SPI-3 Issues

Single Ended Termination Current

T10/98-226R1

Single Ended Termination Current

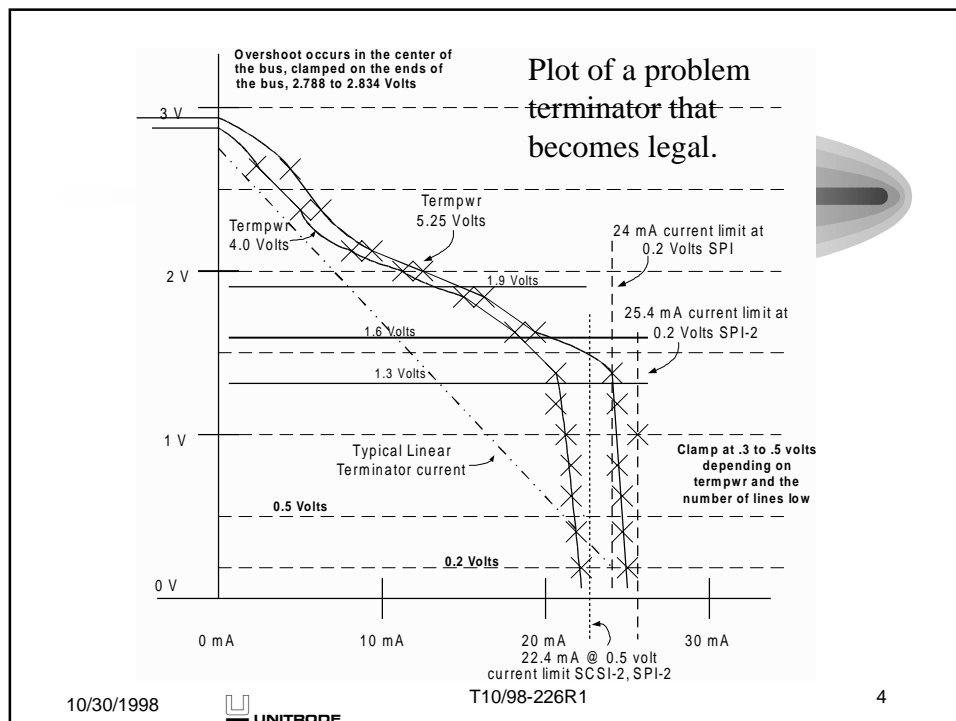
- SPI-2 Agreement 97-236r1 Plenary vote Sept 97:
- Each terminator shall source current to the signal line whenever its terminal voltage is below 2.5 V D.C. and this current shall not exceed 22.4 mA for any line voltage above 0.5 V D.C. and 25.4 mA for any line voltage between 0.5 and 0.2 V D.C. even when all other signal lines are driven at 4.0 V D.C.
- Table 24 & 25 sets the limits for the terminator.
- 24 mA at 0.5 Volts exceeds the driver current with the allowed receiver currents.
